DESIGN REVIEW COMMISSION MEETING MINUTES

7:00 PM - Wednesday, June 15, 2022

TO: Design Review Commission
FROM: Nazaneen Healy, Associate Planner
SUBJECT: SC22-0002 – 632 Leaf Court

SITE PLAN
1/8" = 1'-0"

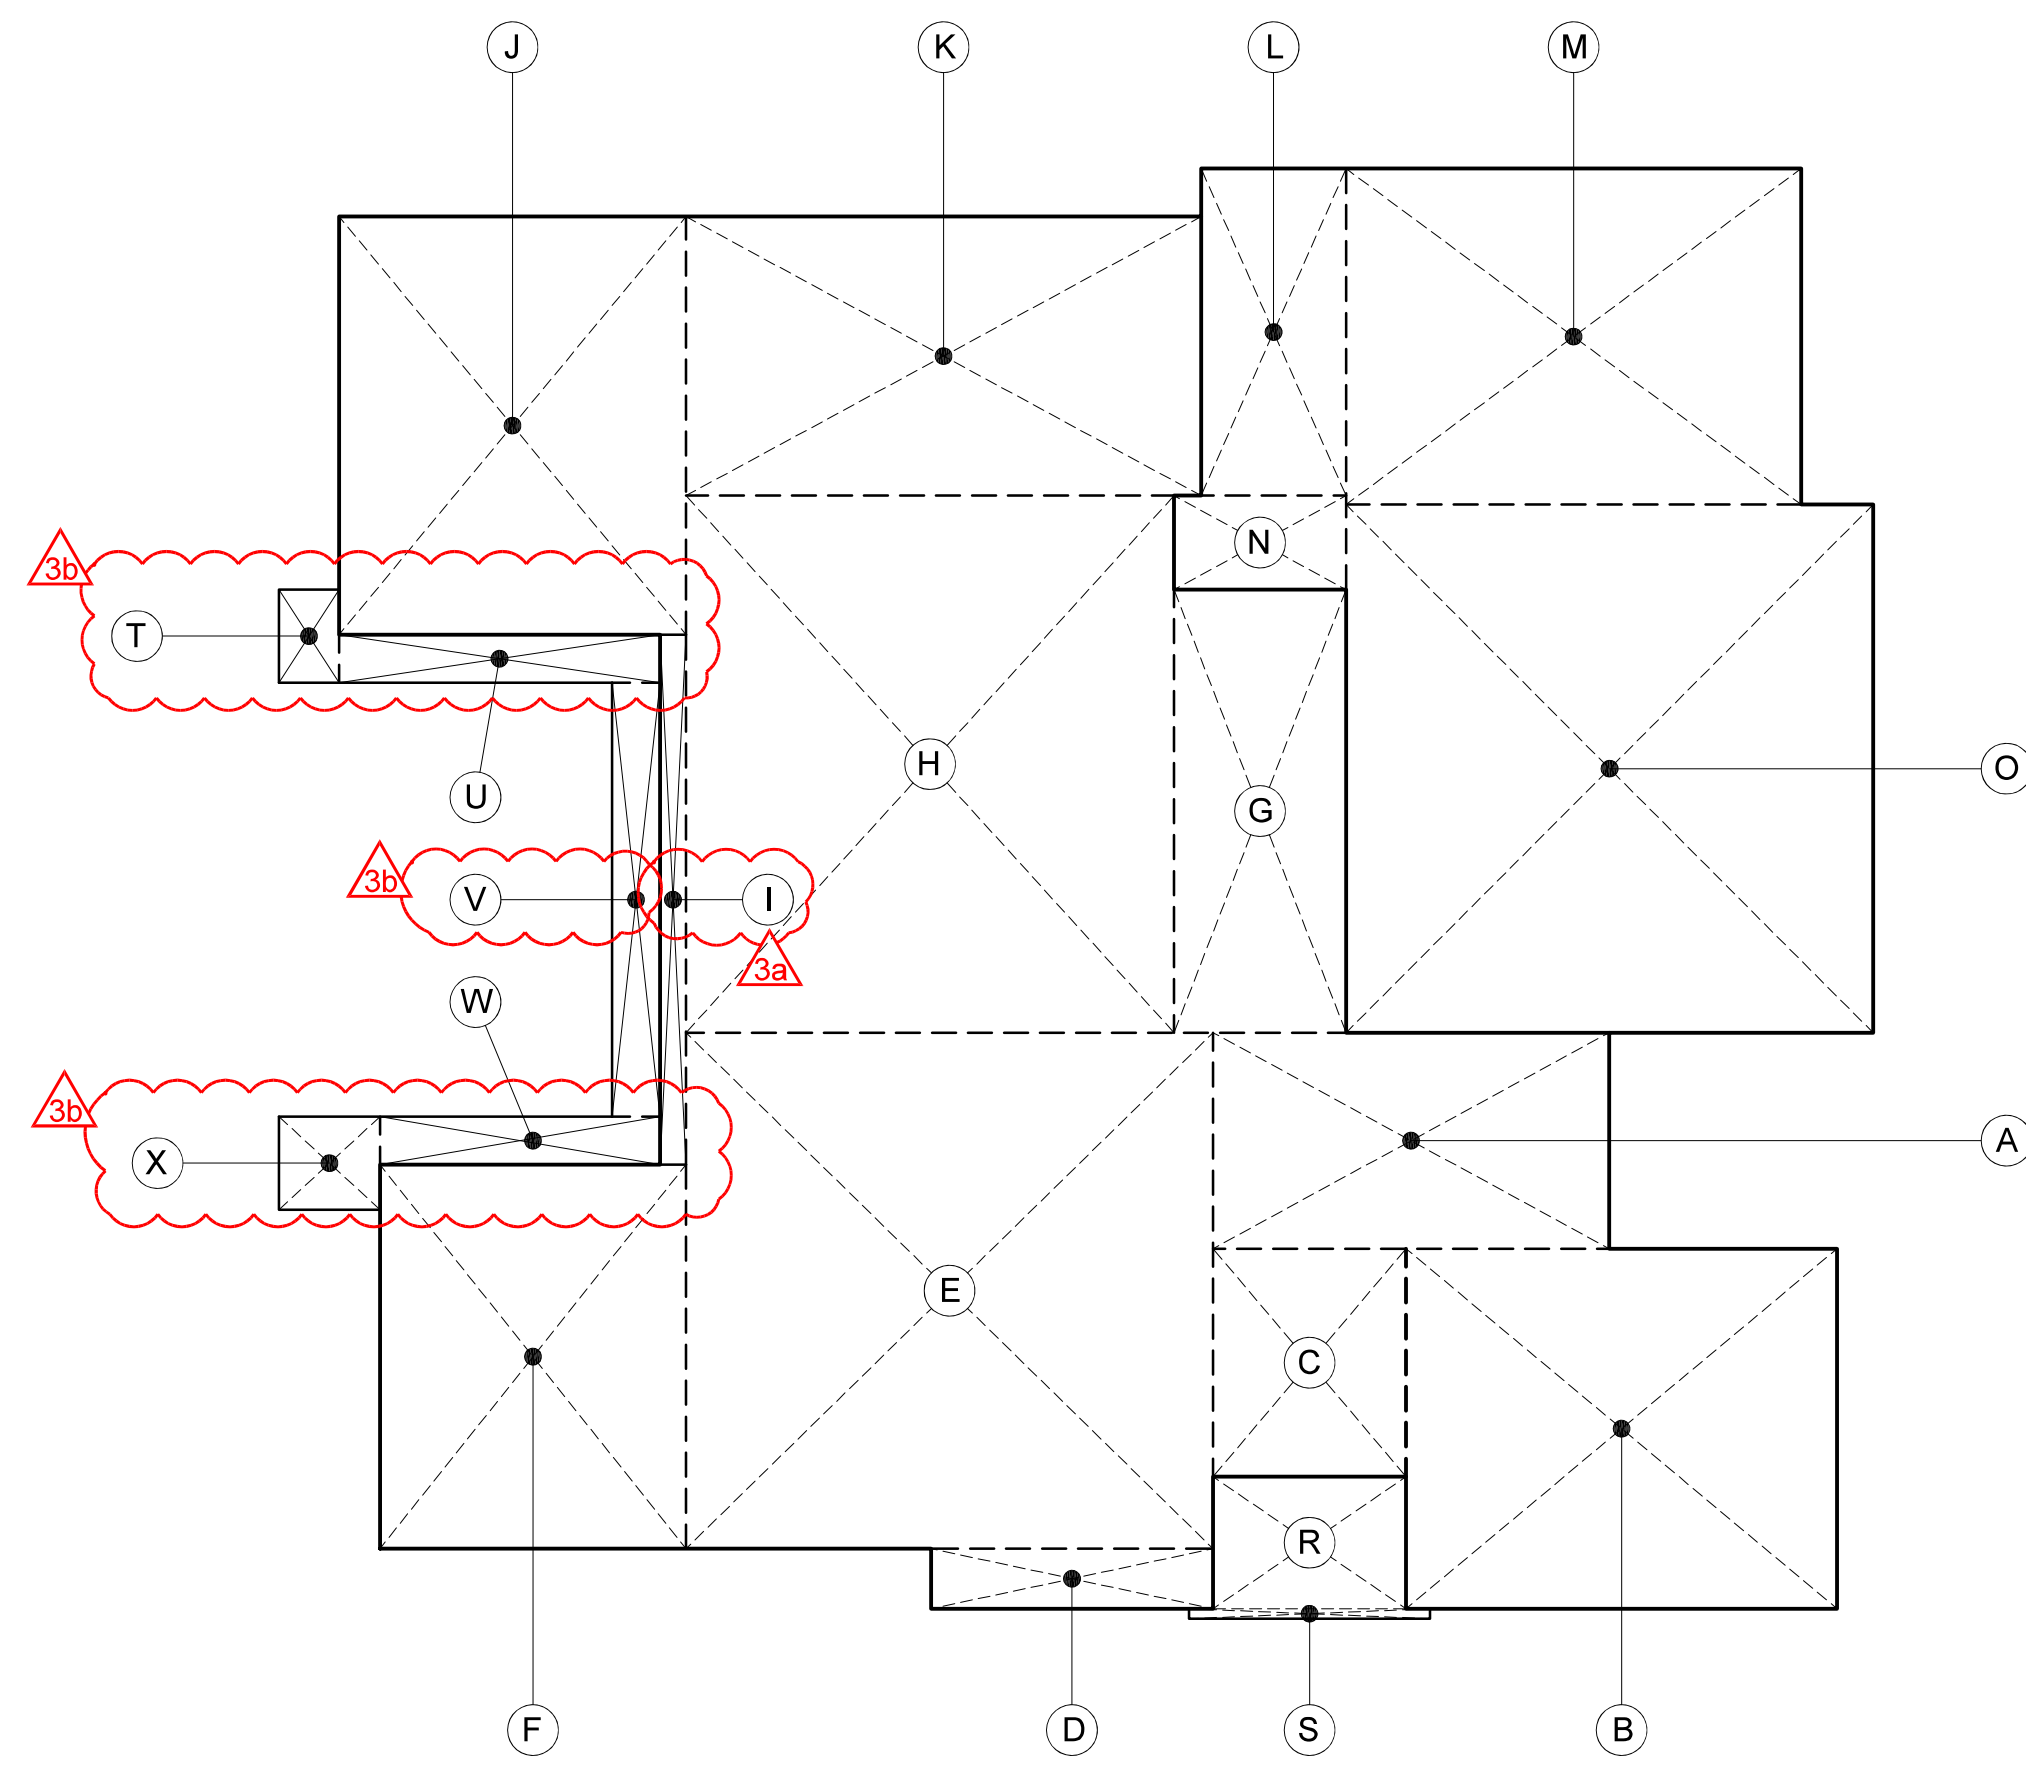
- a. On the Site Plan and Landscape Plans modify the location of the 6-foot tall fencing proposed along the exterior side property line to provide the 15-foot sight triangle required for an adjacent property's driveway within 15 feet pursuant to LAMC Section 14.72.020.

PROPOSED BASEMENT PLAN

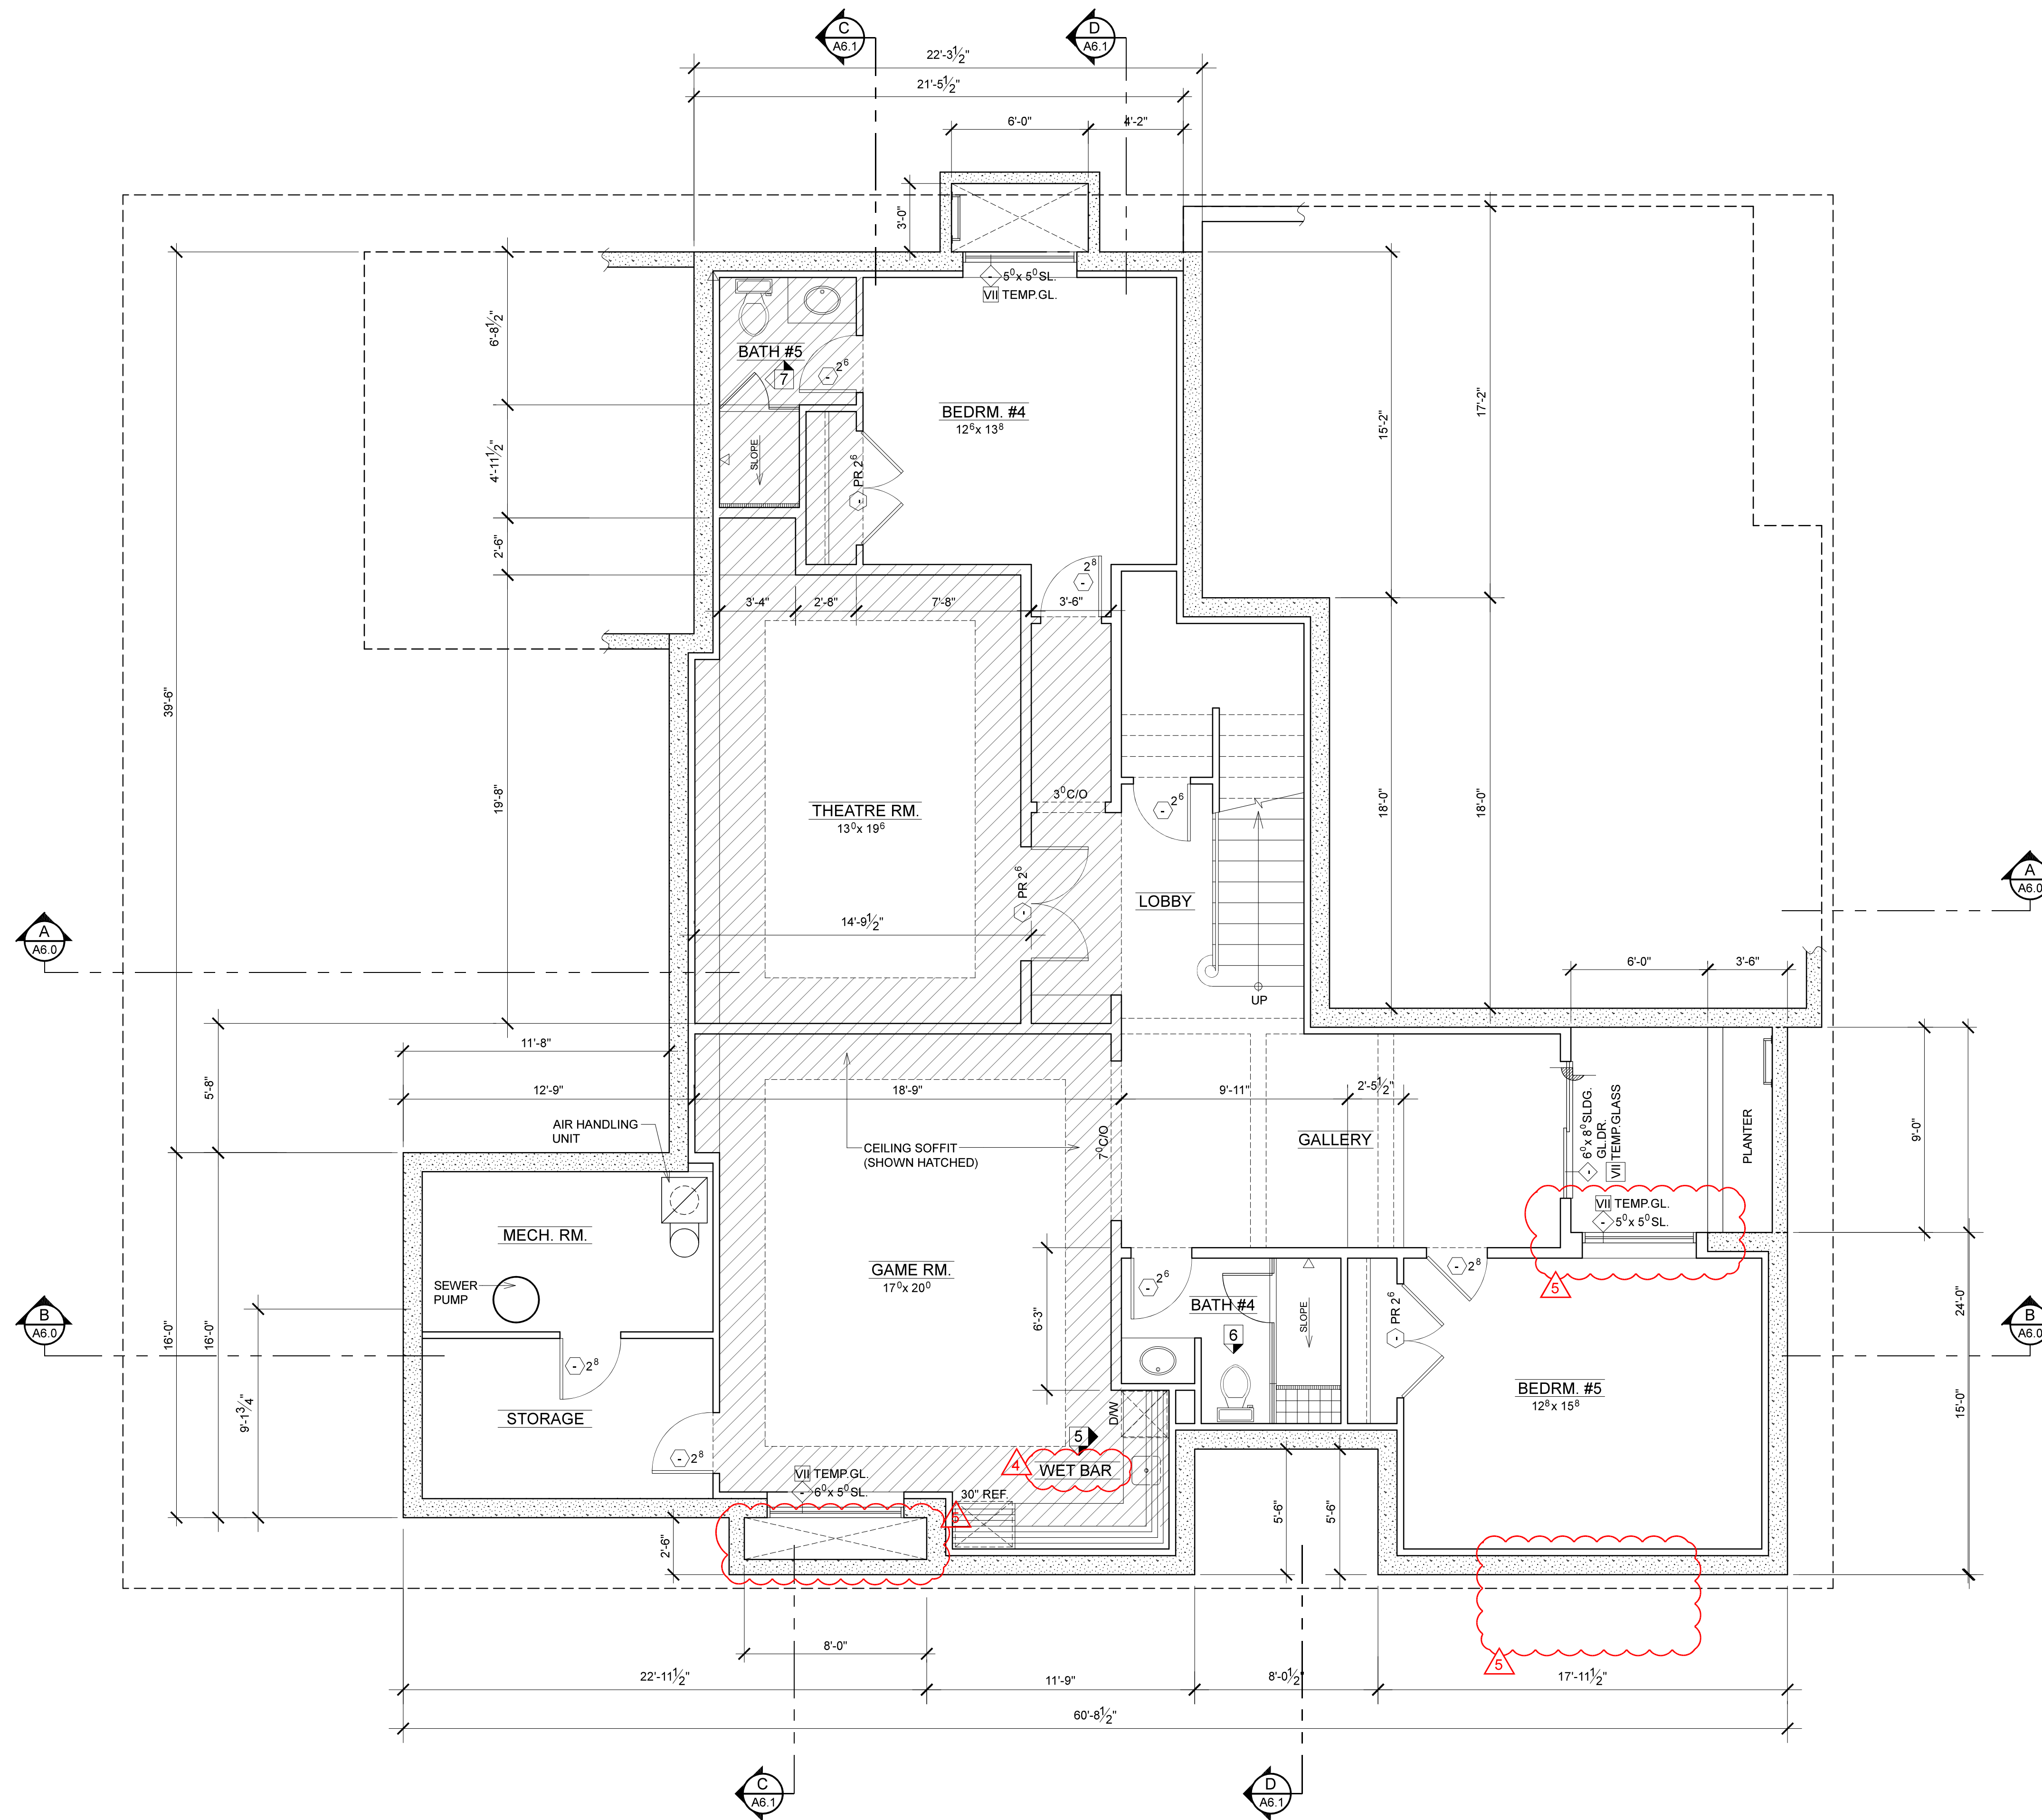
- c. On the Basement Floor Plan add a note indicating: "Wet bar. This area shall not be used as a kitchen. No cooking appliances shall be installed or used in this area."

- d. On the Basement Floor Plan label the mechanical room and storage room as nonhabitable space.
- e. Provide a Shoring Plan for the basement excavation that minimizes potential impacts to the protected trees. The shoring plan shall identify the locations of vertical cuts, slopes, and stitch/shoring piers in relation to the protected trees and cross section detail(s) of the shoring. If potential impacts to trees are identified which include excavation within two-thirds of the dripline, an arborist evaluation may be required to provide recommended design or mitigation measures to reduce impacts to trees.

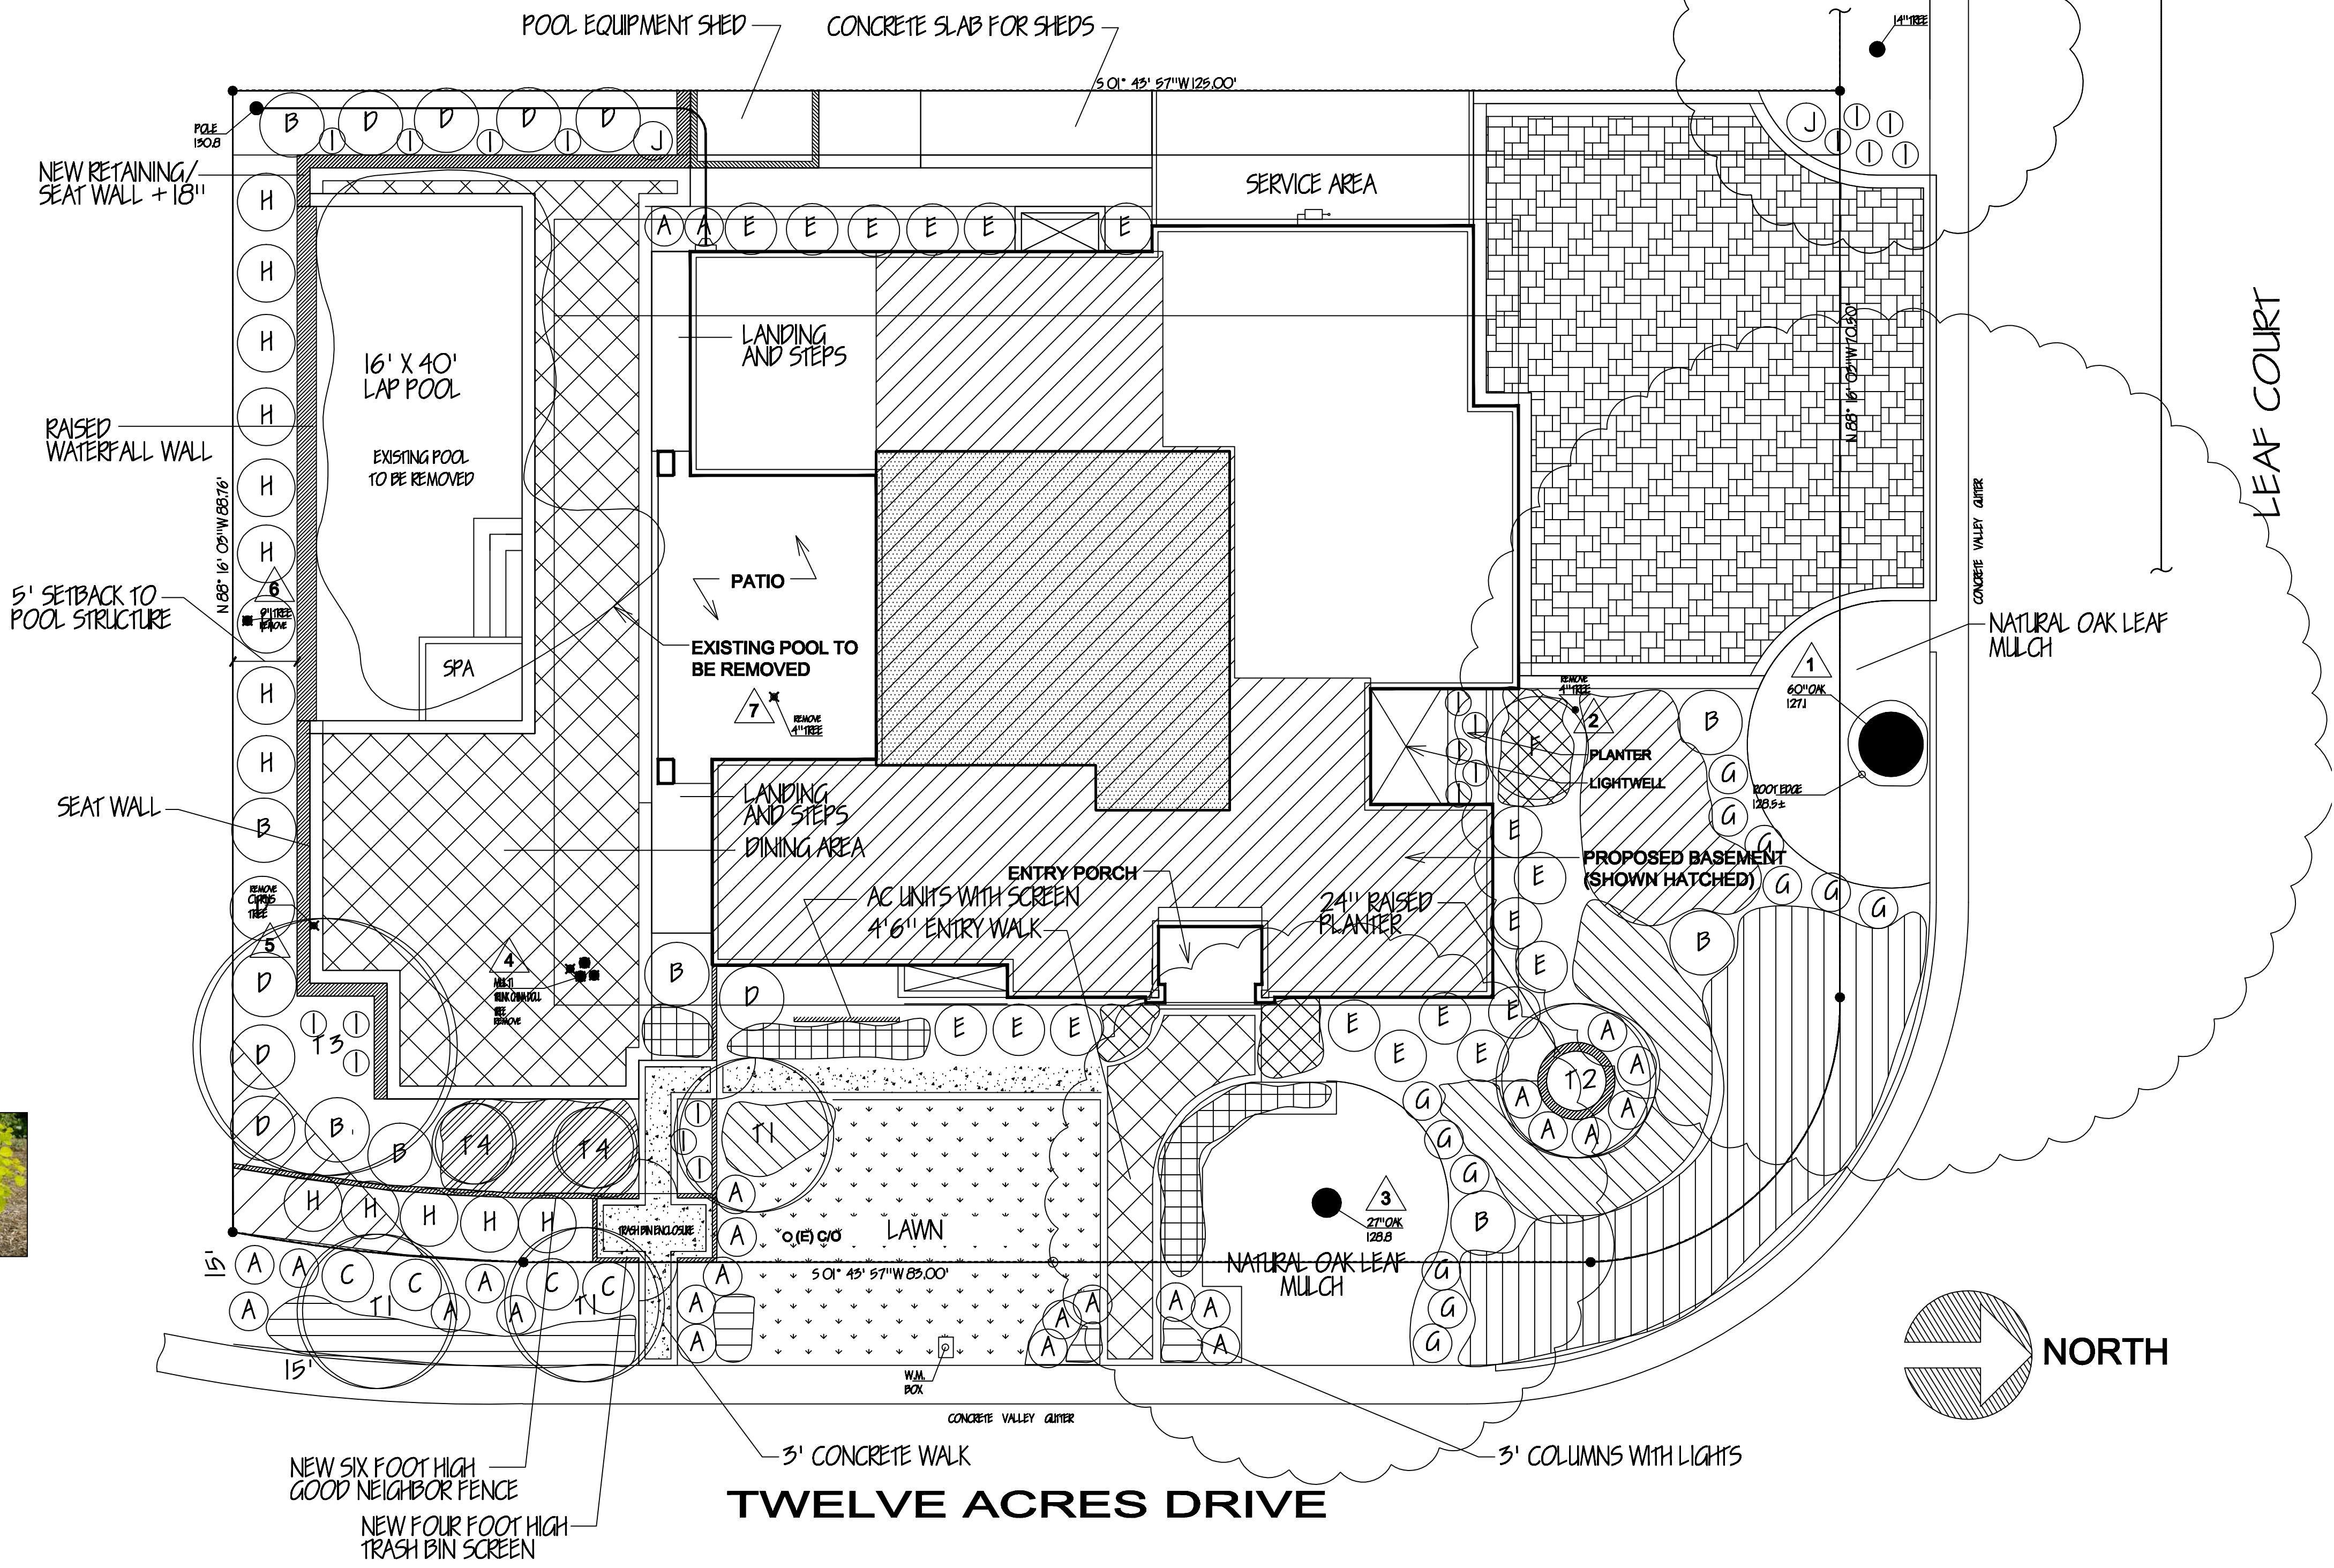
- b. On the Landscape Plans extend the proposed rear yard screen tree plantings along the rear property line to the planting area along the interior side property line.
